☐ NO EXCEPTIONS TAKEN ☐ REJECTED
☒ FURNISH AS CORRECTED
☐ REVISE AND RESUBMIT

DESCRIPTION: GENERAL NOTES	DRAWN BY	DATE
JOB: BRIDGE NO. 43S & 43N I-89 SB OVER U.S. ROUTE 2 I-89 IMPROVEMENTS TOWN OF MIDDLESEX-BOLTON, VERMONT	WL	01/13
	CHKD BY	
	WMJ	01/15
TENSOR 2106-S	APPROV BY	
	SUPERVISOR	W. J. GATTI
PROJ NO. IM-089-2(26)	Q.A.	
CUSTOMER: VERMONT AGENCY OF TRANSPORTATION

JOB NO.	DRG. NO.
116-43S	GN1
	REV. △

PAINT SKETCH "P1"

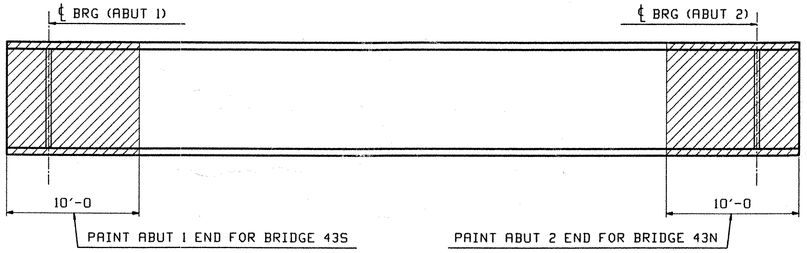
1). ALL STEEL COMPONENTS WITHIN 10'-0 OF END OF GIRDERS AS SHOWN IN SKETCH "P1" SHALL BE COATED WITH THE PROTECTIVE SYSTEM ACCORDING TO SECTION 513 OF THE SPECIFICATION. THE PAINT COLOR SHALL BE BROWN. PAINT SYSTEM MUST BE SYSTEM LISTED ON THE QUALIFIED PRODUCT LIST SECTION 513.02 BROWN COLOR CHIP #20059.
